In terms of the SPA comments, we have provided a response in red to each of the three points below:

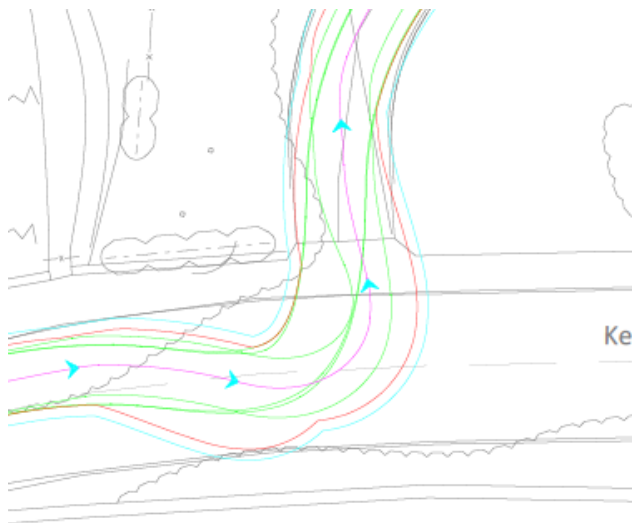
- *A 0.5m gap from the edge of Keresforth Road is not maintained (drawing “Refuse Vehicle Entering Site”).* LTP Response: This is due to the existing alignment and carriageway width of Keresforth Road and is consistent with the movements of existing refuse vehicles travelling along Keresforth Road including those which currently serve Wood End Court. The proposed access arrangements provide a betterment to the existing situation in terms of refuse vehicle movements as vehicles are not required to encroach the opposite side of the carriageway when turning in and out of the proposed access compared to the existing Wood End Court junction.
